V2_Grading & Erosion Control Plan_COMMENTS.pdf Markup Summary

PCD File PPR265

ASCENT CHURCH

POND OUTLET STRUCTURE PROFILE
SCALE: 3/4"=1'

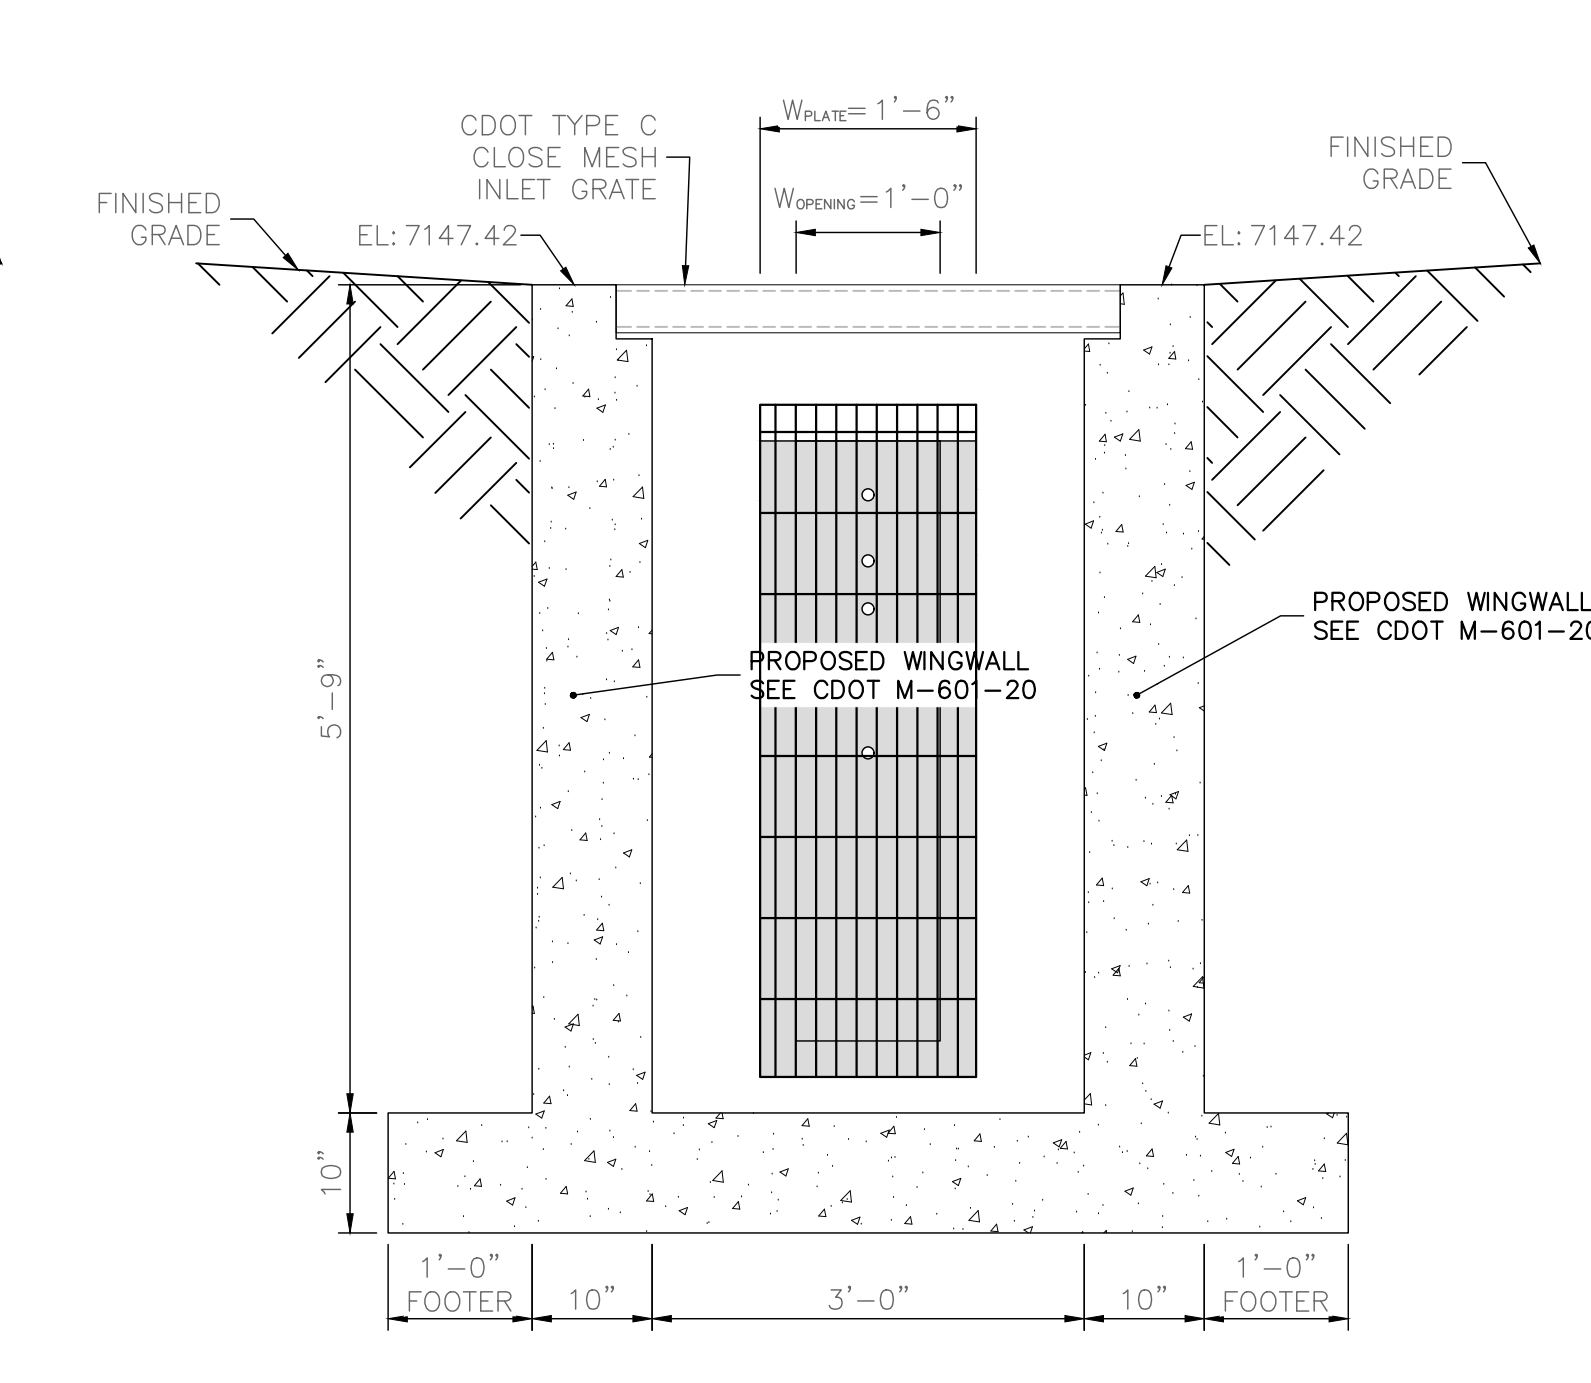
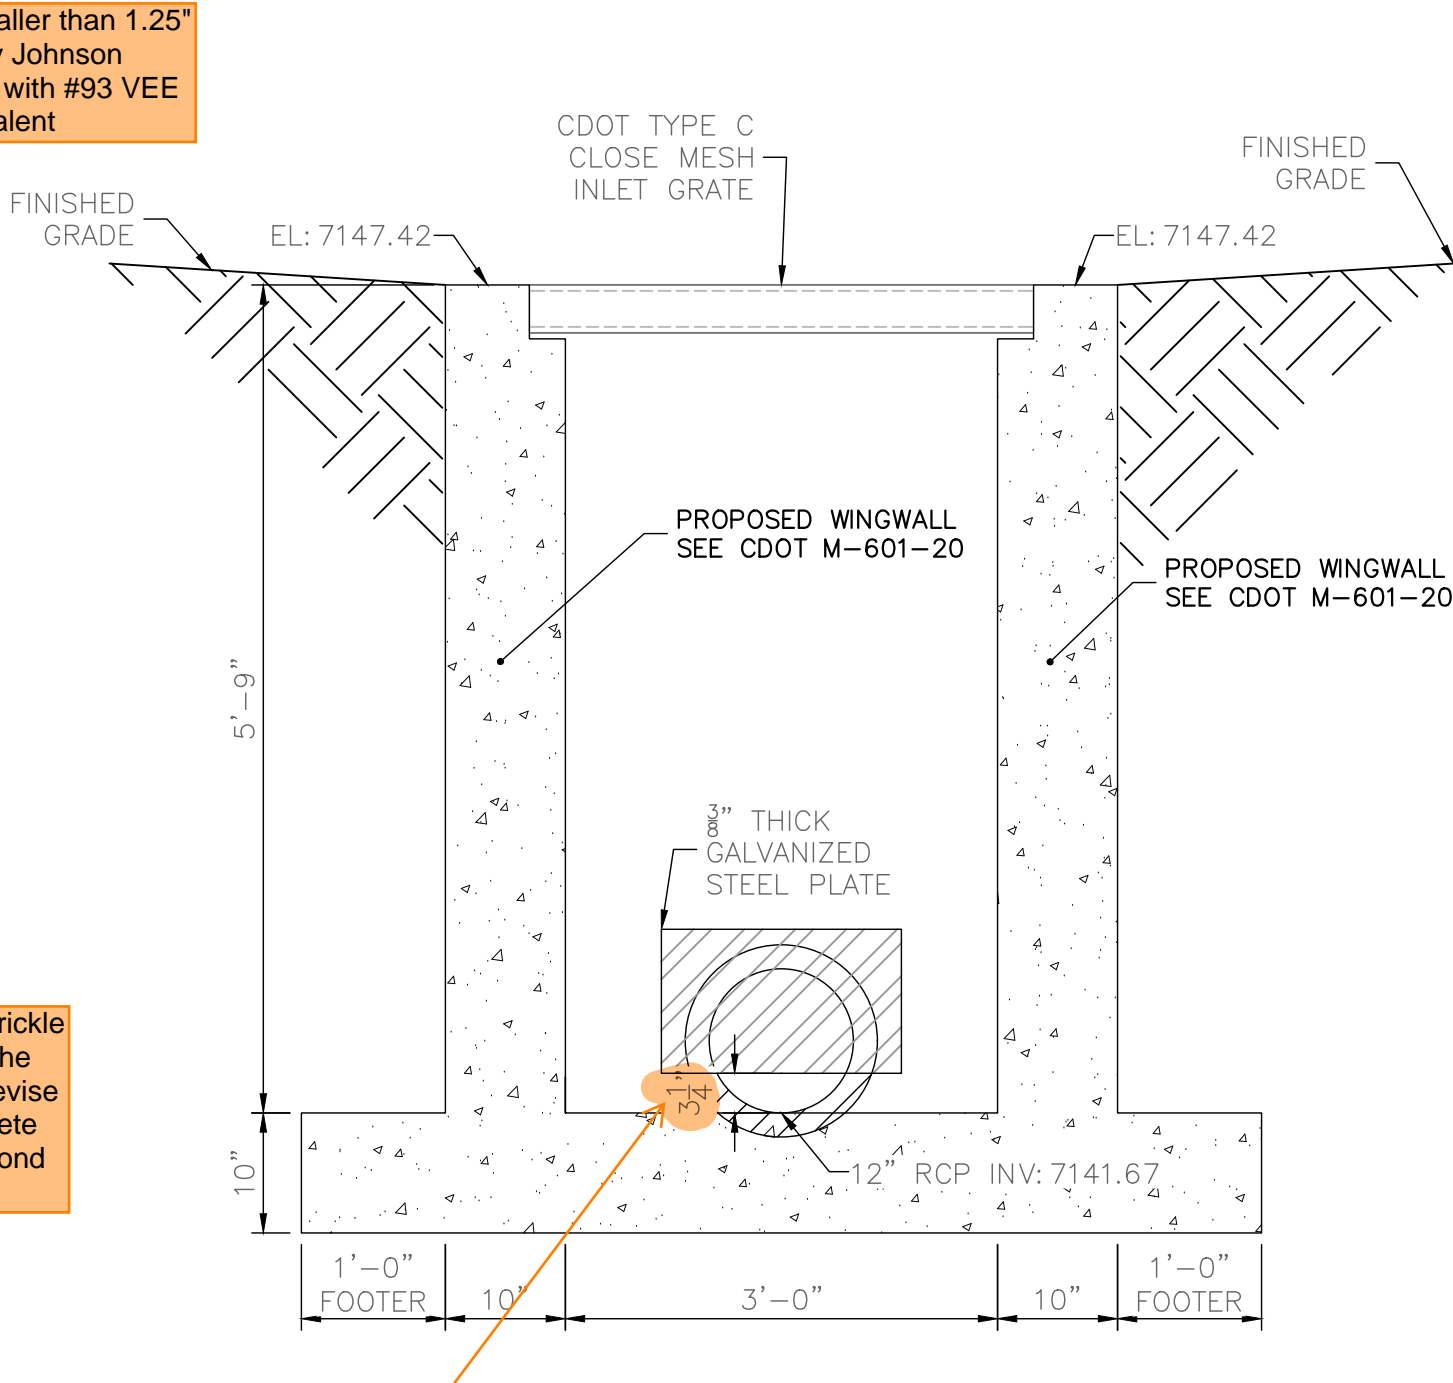
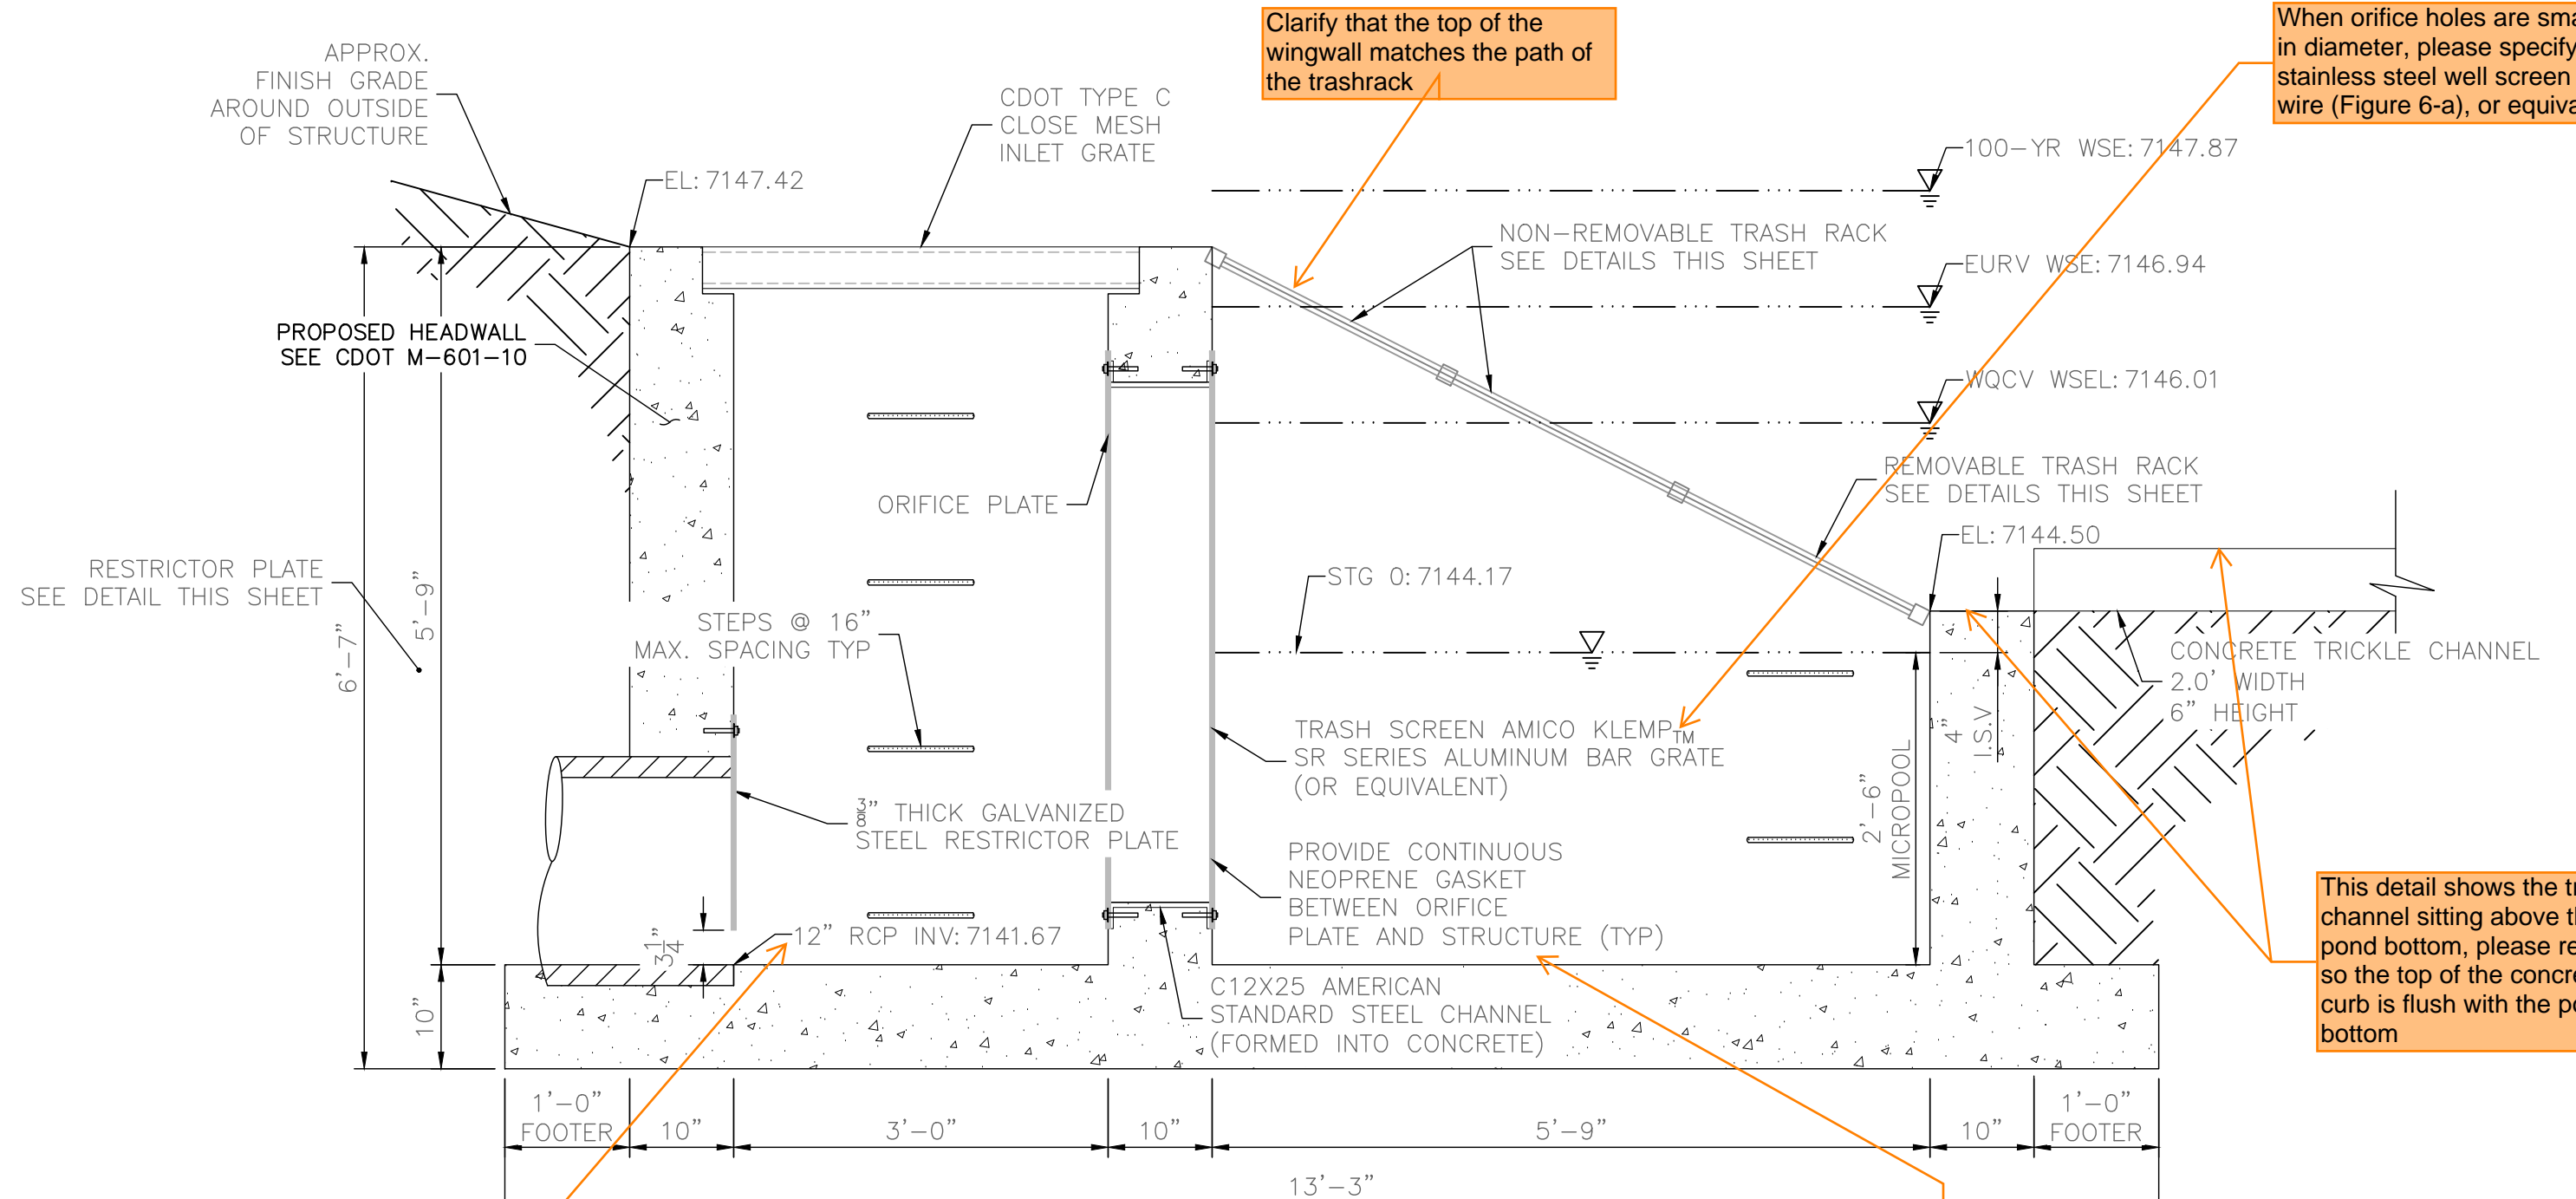
Per DCMv1 Section 4.3 (UD Figure 6-a) and DCMv2 Section 11.3.1 (1st paragraph), outlet pipe should be 18" minimum.

Clarify that the top of the wingwall matches the path of the trashrack

This detail shows the trickle channel sitting above the pond bottom, please revise so the top of the concrete curb is flush with the pond bottom

POND OUTLET STRUCTURE PLAN
SCALE: 3/4"=1'

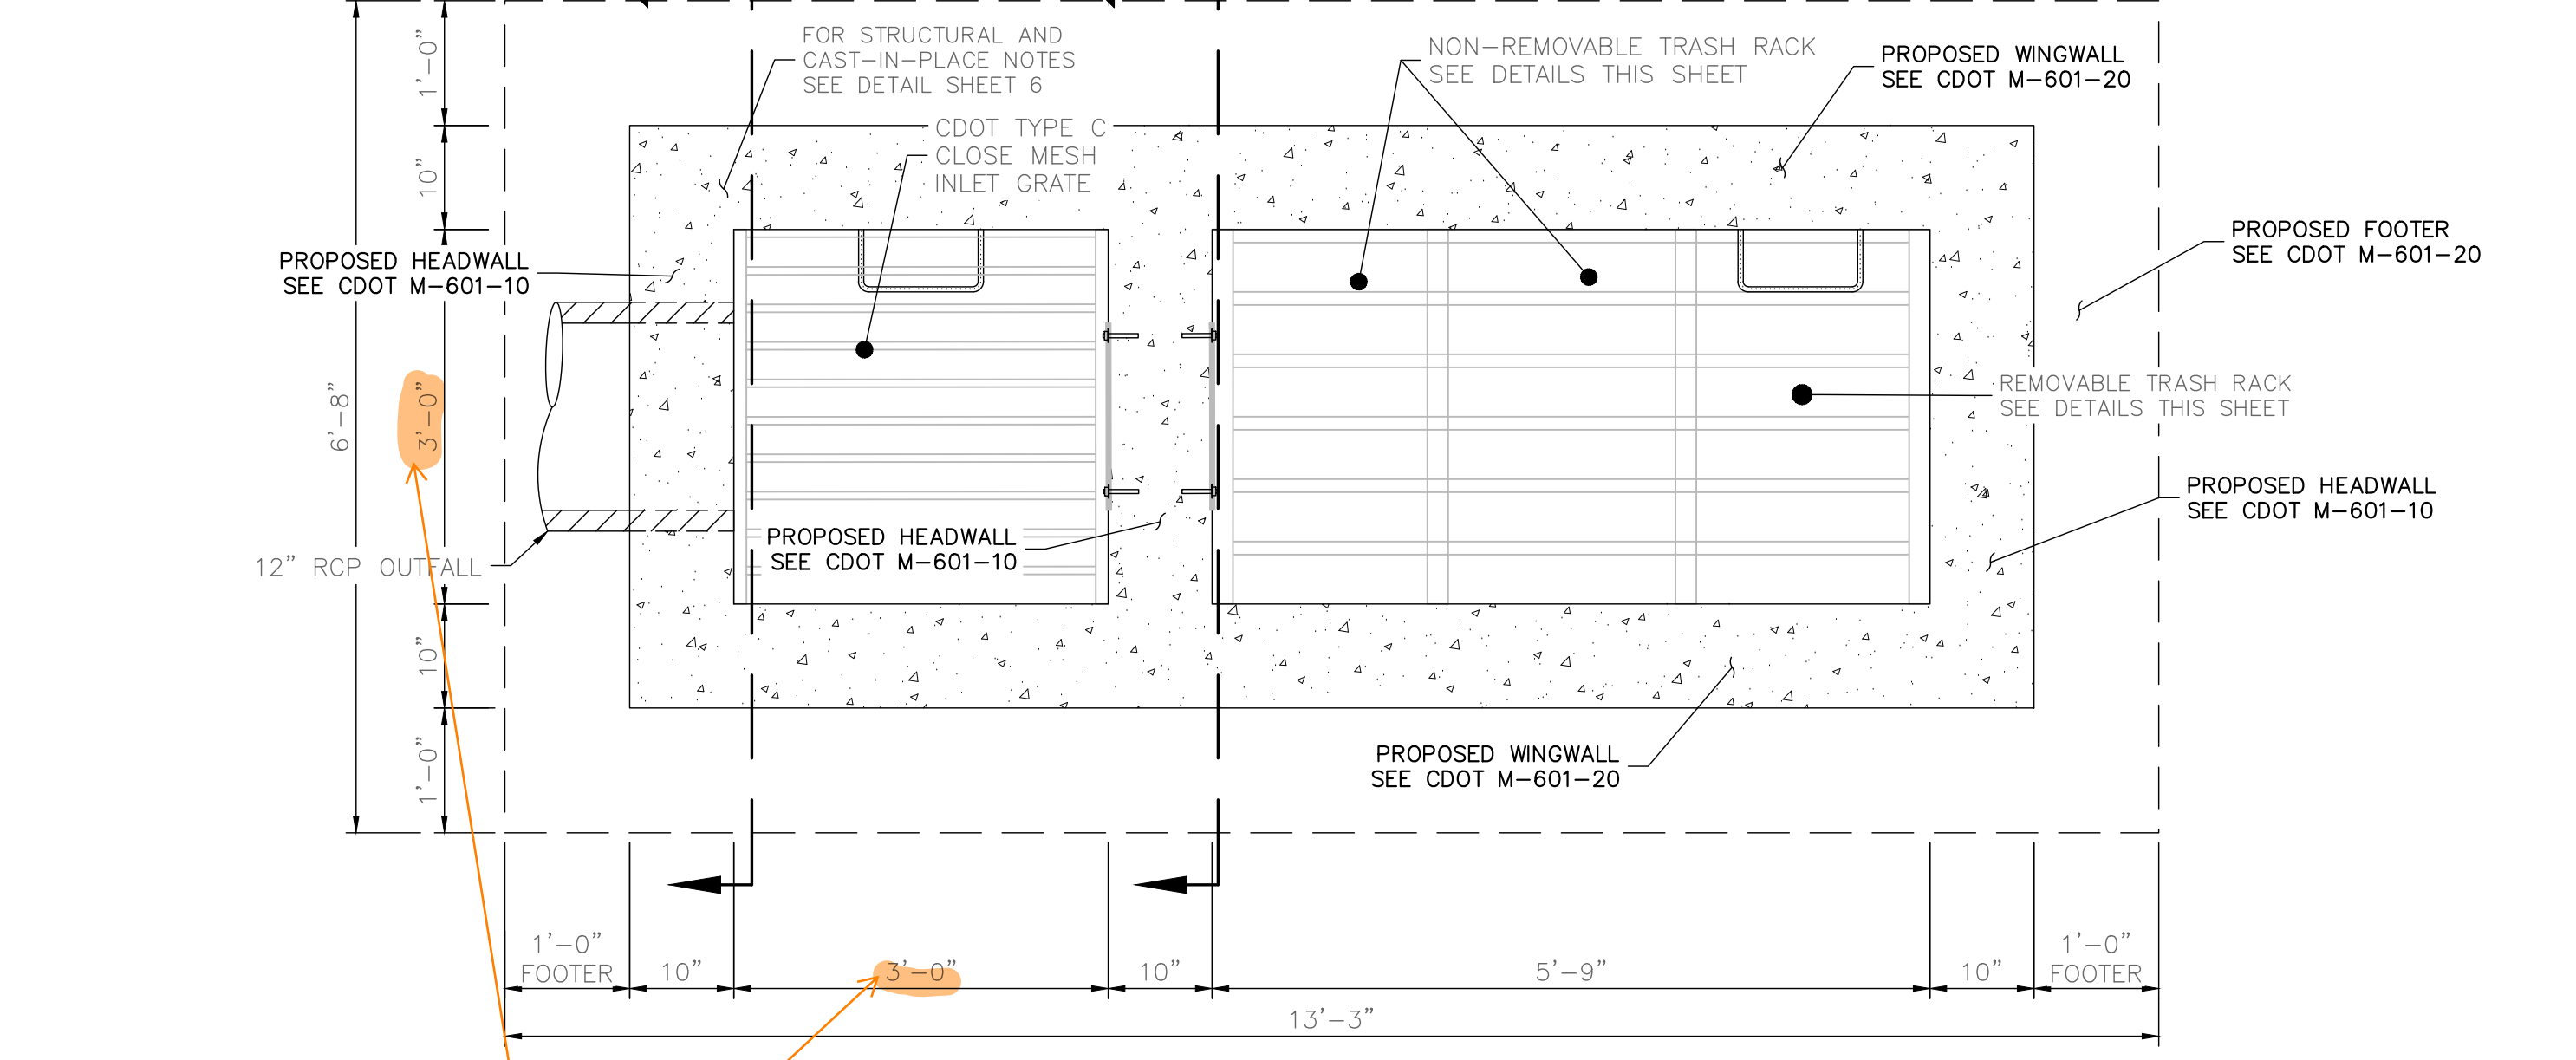
When orifice holes are smaller than 1.25" in diameter, please specify Johnson stainless steel well screen with #93 VEE wire (Figure 6-a), or equivalent

Provide more detailed gasket info like thickness, width, brand/model, etc.
Based on input gathered from industry experts, below is the recommended gasket spec:
The gasket shall be made of 1/4-inch thick, 60 durometer EPDM rubber in a continuous sheet the size of the orifice plate. The sheet shall be placed between the orifice plate and the concrete wall, with the width of the overlap between the plate and the concrete. Openings shall be cut into the sheet corresponding to the plate bolt holes and the concrete wall opening, cuts made either by the contractor in the field or by the manufacturer. Or equivalent gasket approved by EPC. Note that caulk is not an approved equivalent and will not be accepted by EPC.

Dimension does not match "height above pipe invert" in design spreadsheet

The gasket shall be made of 1/4-inch thick, 60 durometer EPDM rubber in a continuous sheet the size of the orifice plate. The sheet shall be placed between the orifice plate and the concrete wall, with the width of the overlap between the plate and the concrete. Openings shall be cut into the sheet corresponding to the plate bolt holes and the concrete wall opening, cuts made either by the contractor in the field or by the manufacturer. Or equivalent gasket approved by EPC. Note that caulk is not an approved equivalent and will not be accepted by EPC.

ORIFICE PLATE DETAIL
SCALE: 3/4"=1'

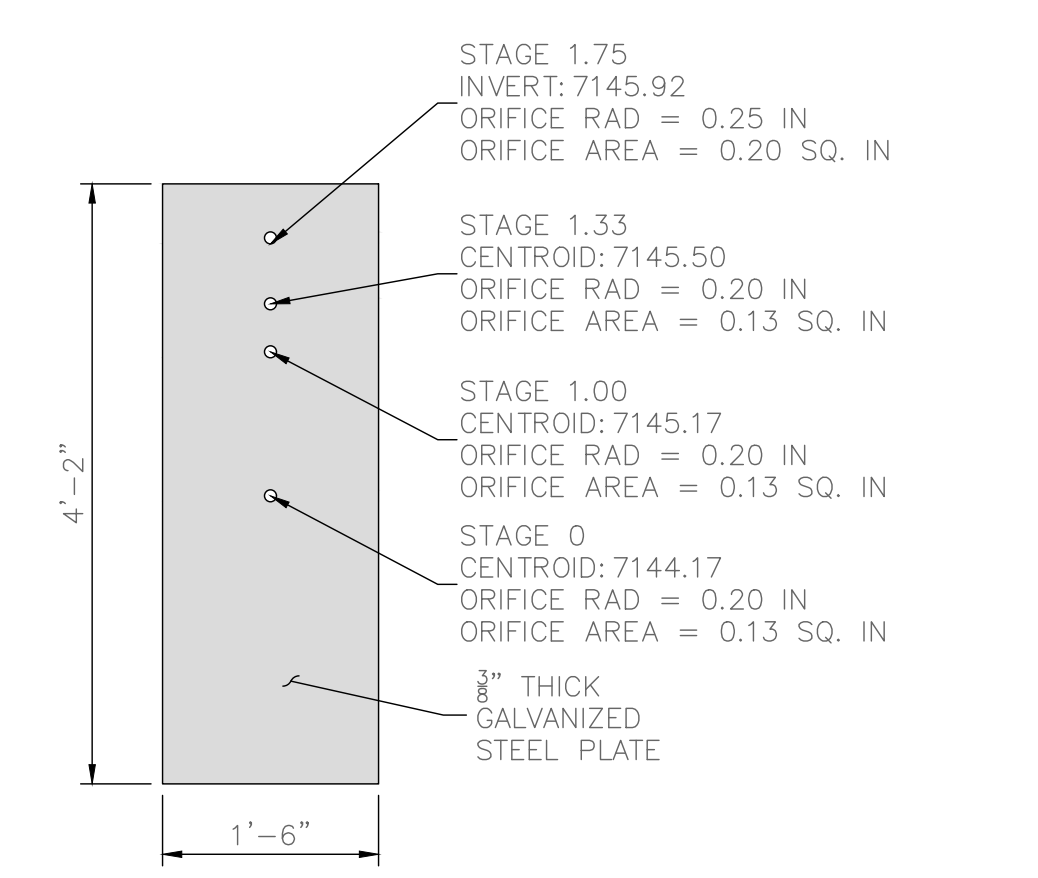
Does not match design spreadsheet
